Trinity Islands Site C, Manchester

Non-Material Amendment | 21.01.2026

ZC-SHP-A180-RP-XX-NMA01 | P01

4.3 - Landscape // Proposed Tree Planting Plan

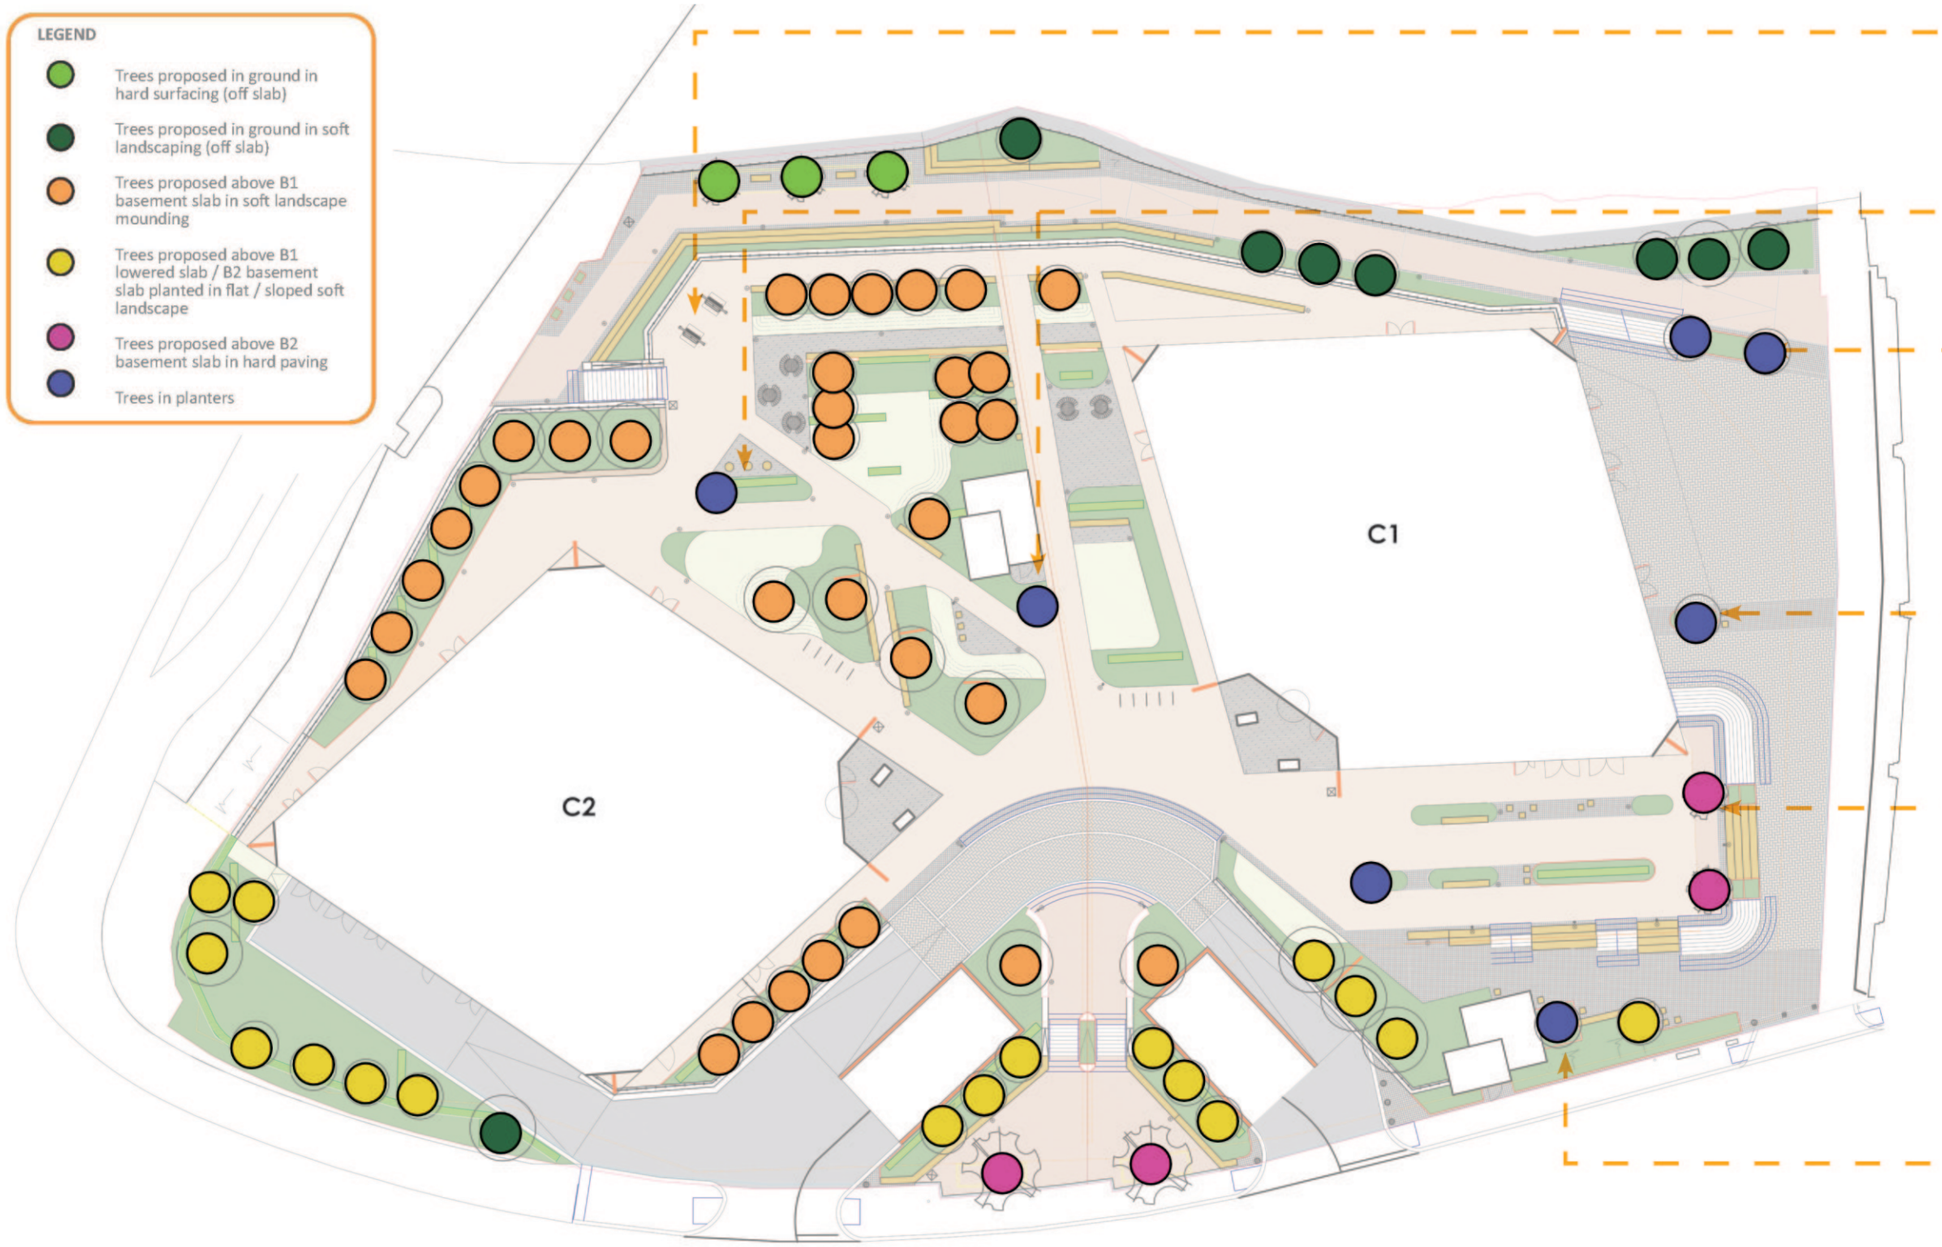
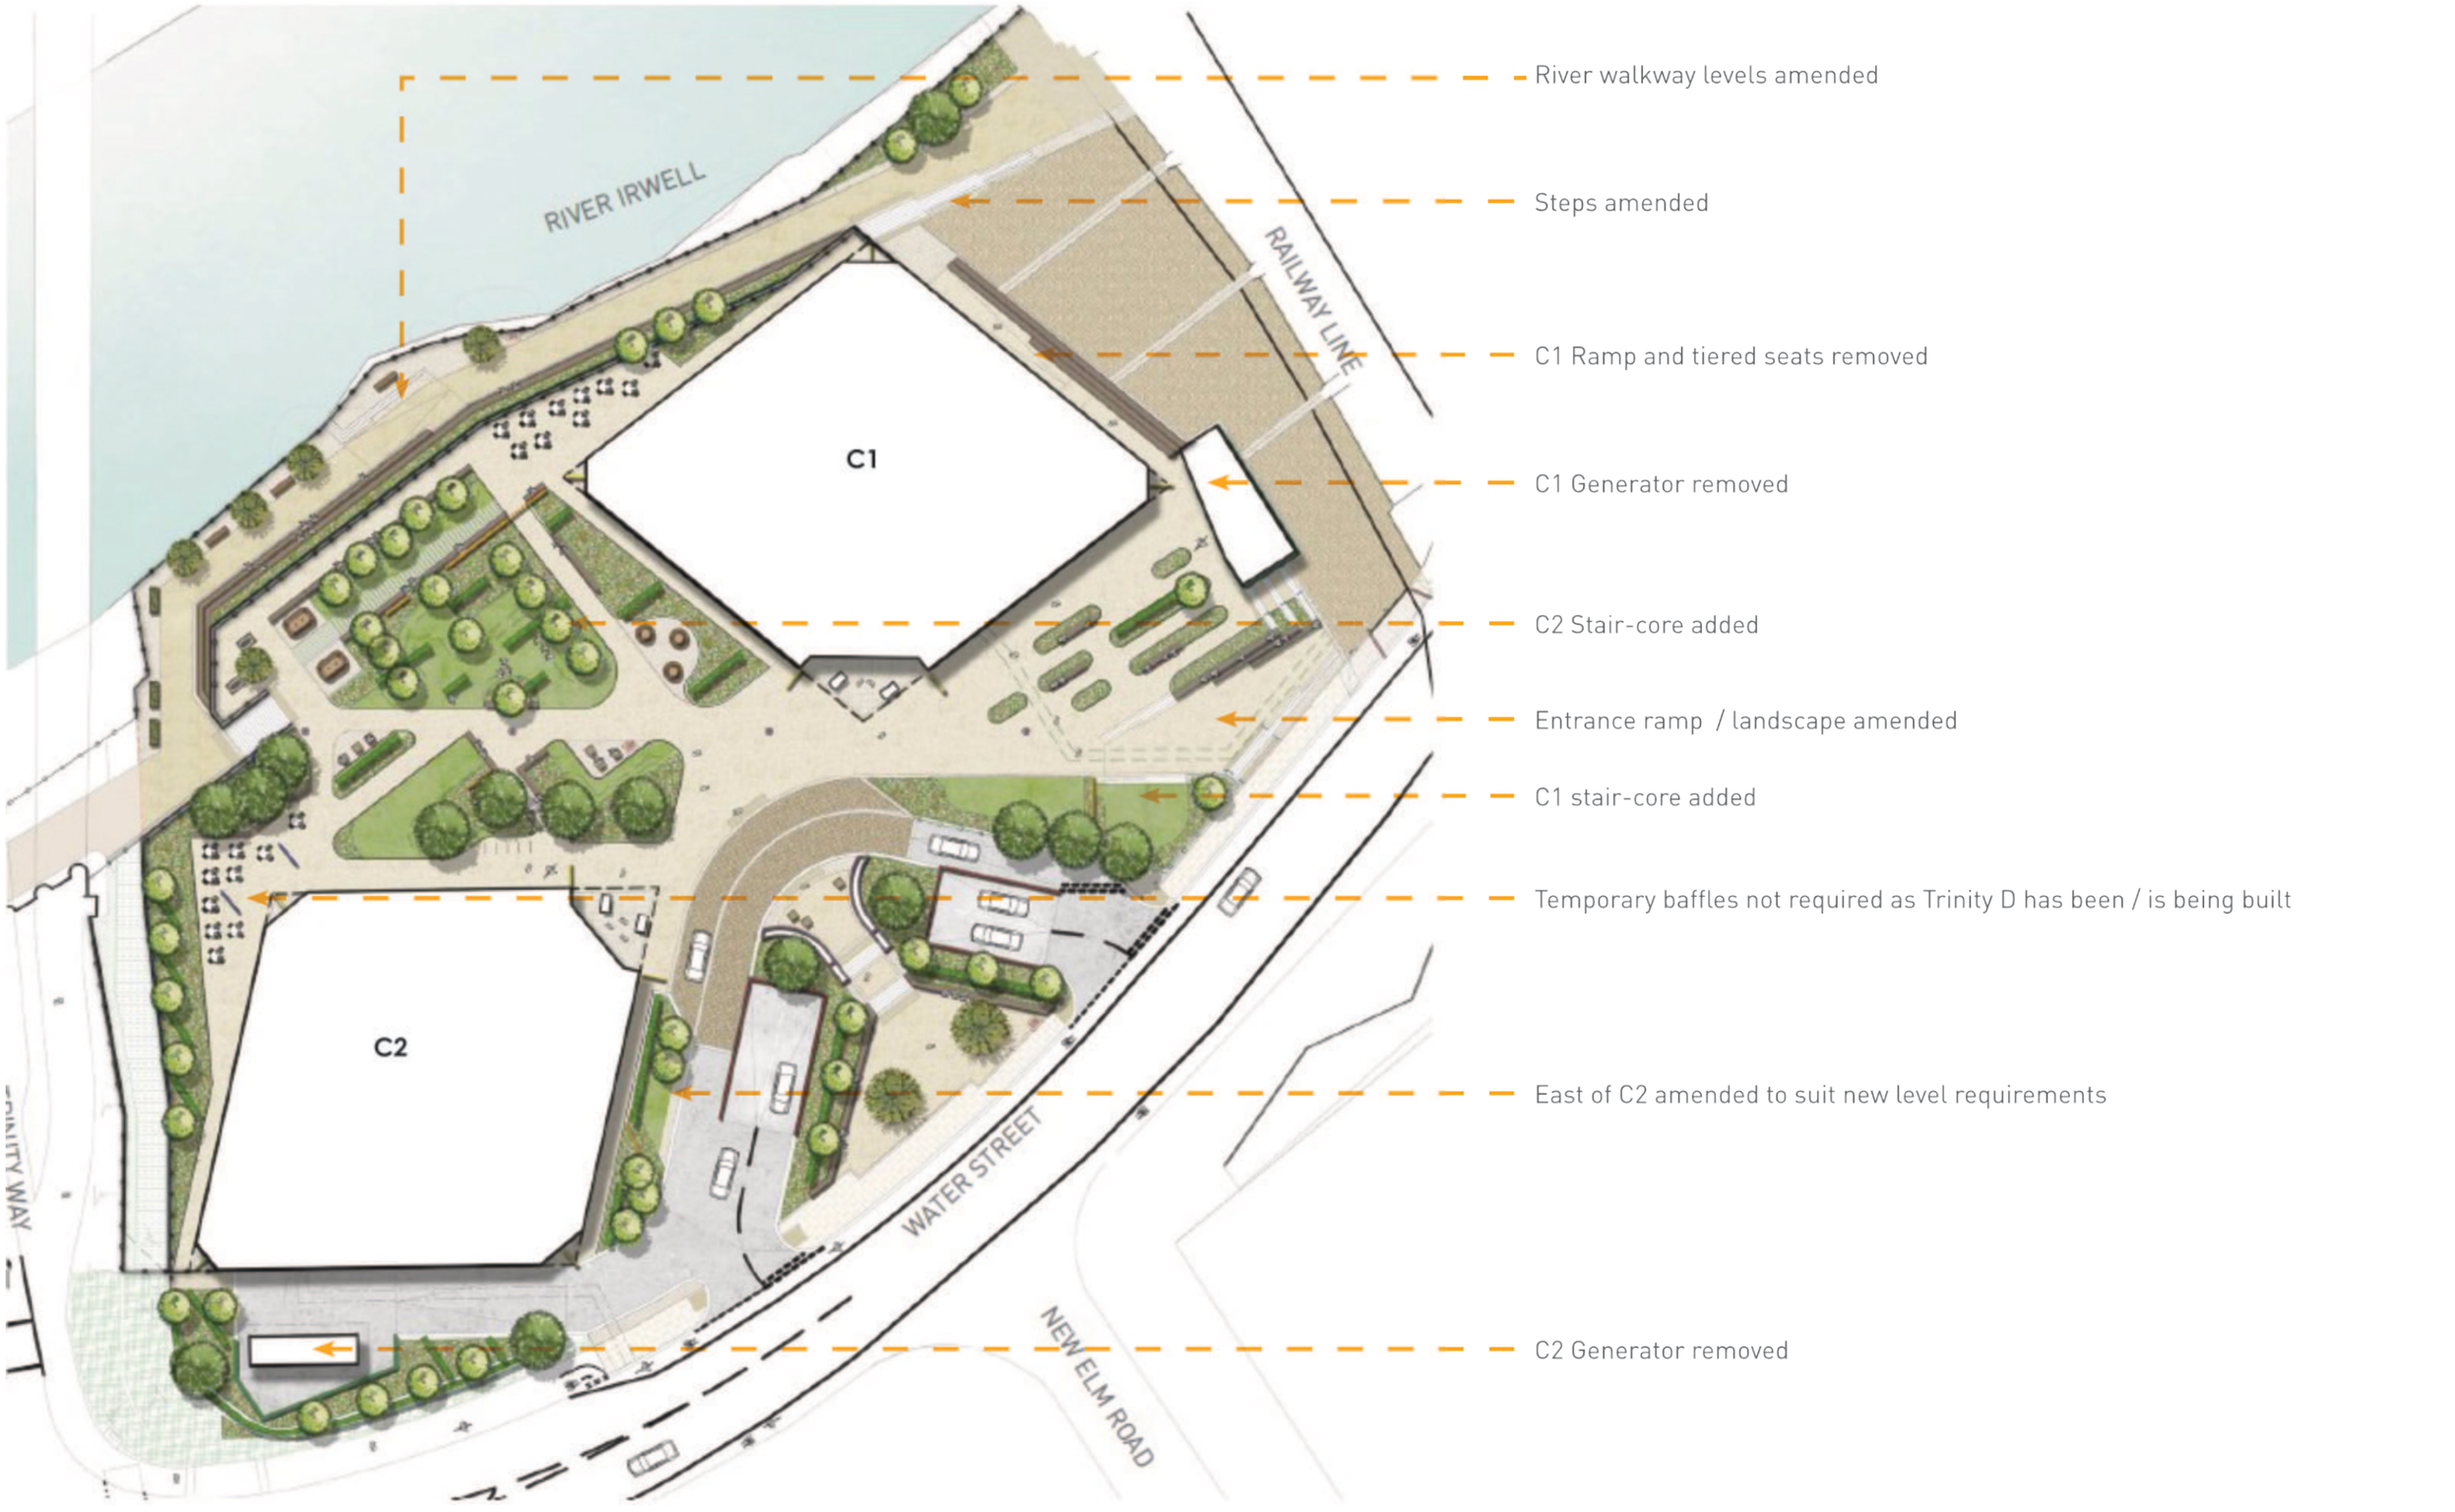
Removal of a tree in hard landscape due to the podium slab moving west and no zone for in-ground trees.

Addition of 2 x small planters with small tree / large shrub as feature markers along the path.

Additional two trees to form a bookend to the steps and soften the predominantly hard landscape space

Additional tree to soften the predominantly hard landscape space. Tree aligns with the additional two trees on the upper public realm

Additional two trees to soften the predominantly hard landscape space. Tree aligns with the additional tree at the lower landscape level.

Additional tree to soften the approach route and provide screening to the stair-core (9m sq soil volume)

Planter shown to form part of the building arrangement and a reference to the geometry.

4.3 - Landscape // Proposed Layout - River Walkway

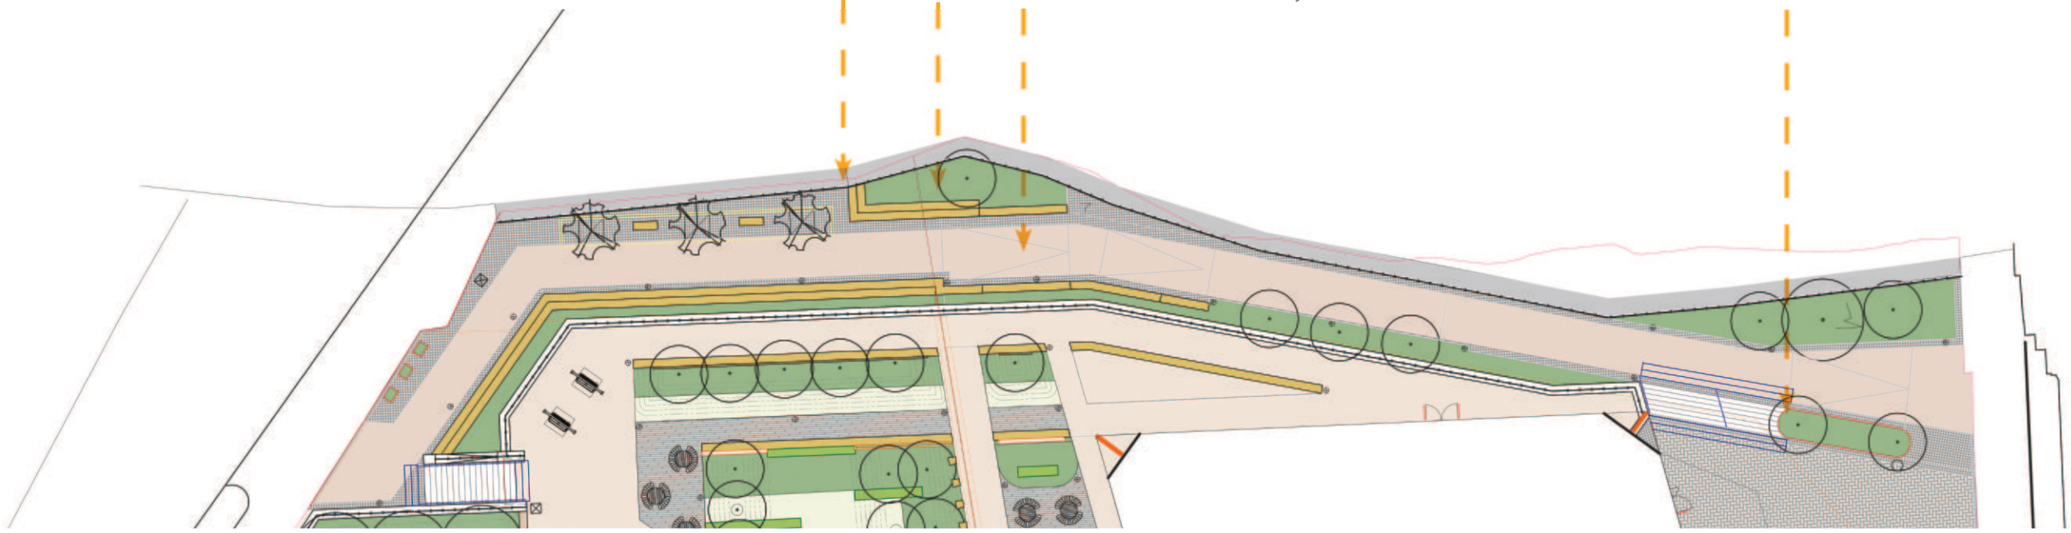
Detailed river wall survey highlighted a greater level change between the two existing levels. Change from several steps to two tiered seat walls to take out the level change

Area previously shown as hard landscape.
Now proposed as soft landscape.

1:21 ramp extended in length due to greater level change.
Slight amendment to seat heights and pathway levels

Detailed level survey required gradients amending to the service yard. Planter creates a bookend to the steps and helps transition levels falling in different directions between the service yard and river walkway

4.3 - Landscape // Proposed Layout - Water Street to the River Walkway

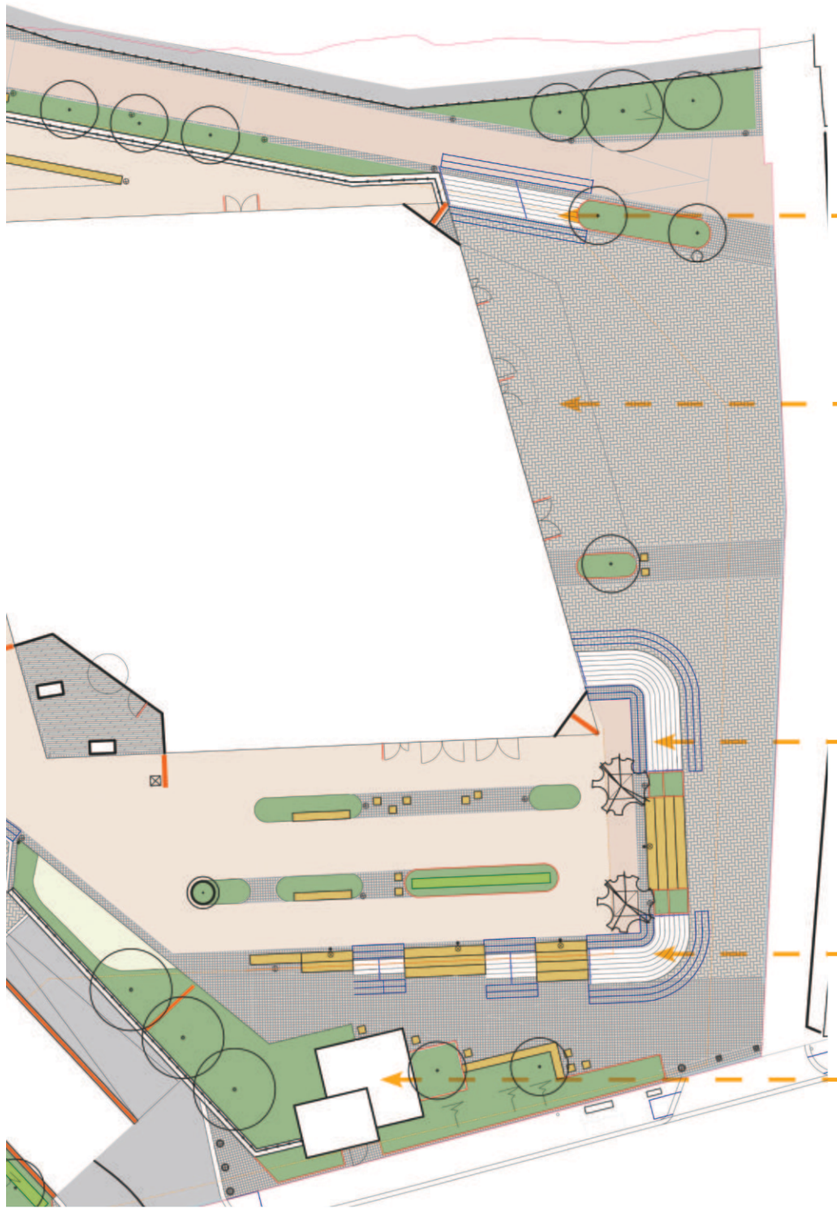
Area previously a long line of tapered steps. Detailed level survey required gradients amending to the service yard. Planter creates a bookend to the steps and helps transition levels falling in different directions between the service yard and river walkway

The ramp and tiered seating shown at planning has been removed with ramped access provided at Water St.

Area designed to be open to allow the access to the various doors along the facade and for ease of vehicle tracking.

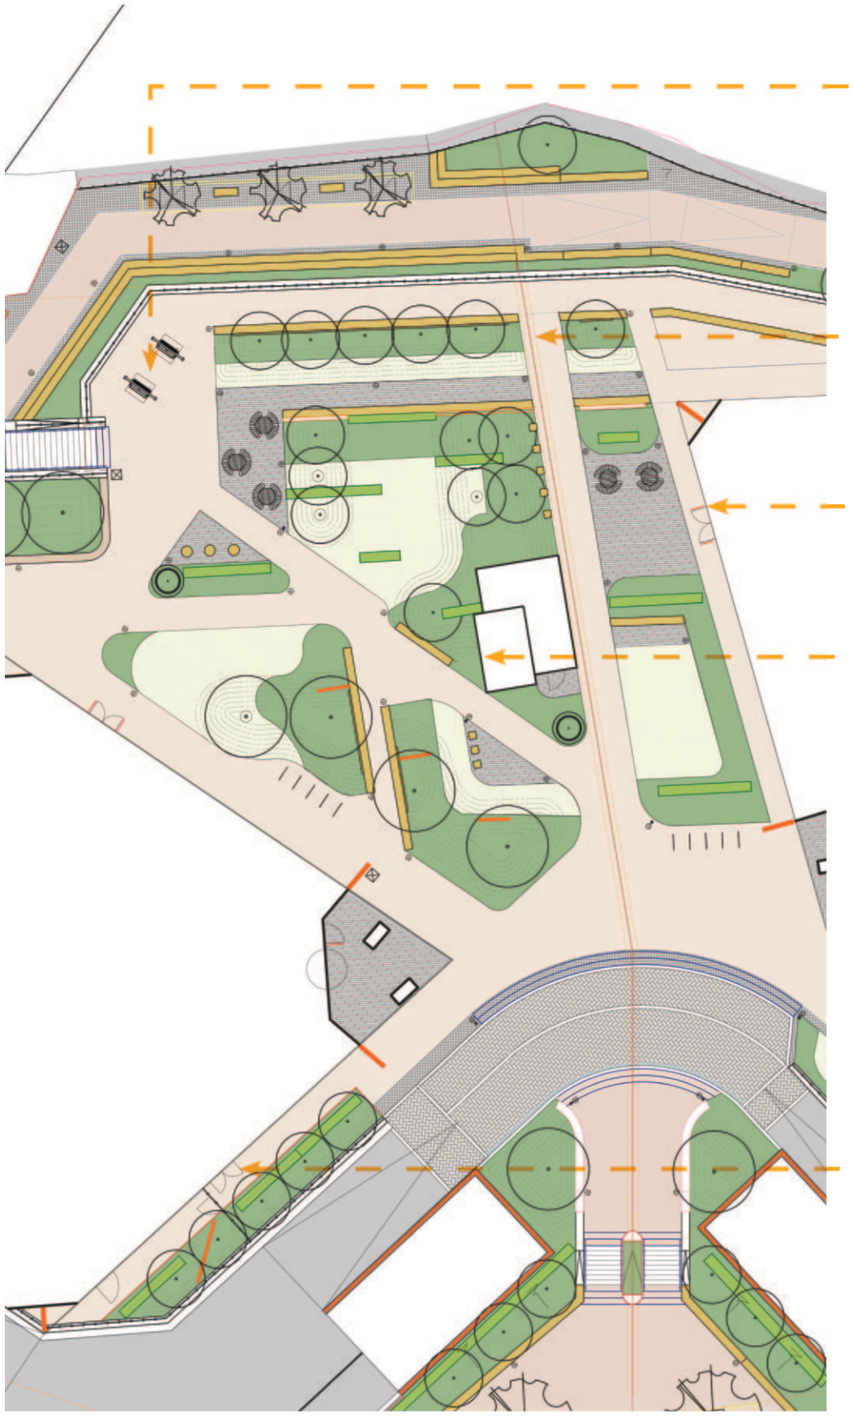
Location of previous C1 Generator building removed and area landscape with steps and tiered seating / planters.

More open interface with the railway arches

Amendments to the step and tiered seating configuration since planning to suit the area by the C1 generator was located so the entrance steps read as one element.

Addition of the C1staircore along Water Street. Building integrated within a sloped soft landscape planting area

4.3 - Landscape // Proposed Layout - Core Public Realm

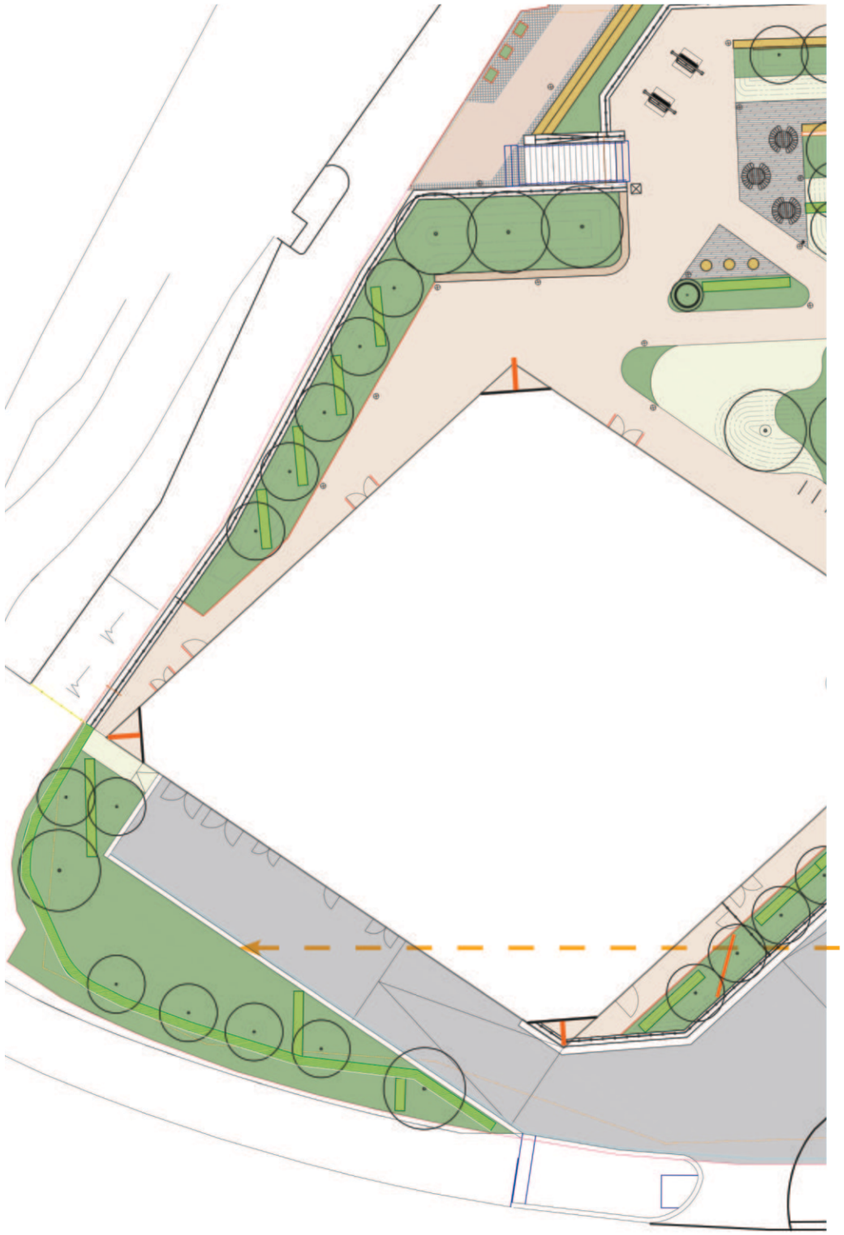
Proposed in-ground tree removed due to the B1 slab extending. Area retains the swings and forms a viewing area over the river.

Path orientation amended to suit the C1 / C2 basement line.
Creation of a wider landscape zone to the west of C1, allowing the west - east tree planting line to continue into this wider bed.

Additional door added to the west of C1 to provide access to the commercial unit. Landscape previously soft landscape now has a hard landscape area to allow access and spill out area

Addition of the C2 stair-core within the parkland.
Minor modification to earth mounding and tree distribution within the area.
Small planters added as features along the diagonal pathway.

Additional doors added to the eastern elevation of c2. Previously landscape sloped with the car park ramp, but now there is a requirement for level access.

Trees, hedges and baffle located at the upper public realm level. Dressed stone wing wall mirrors that on the exit lane.
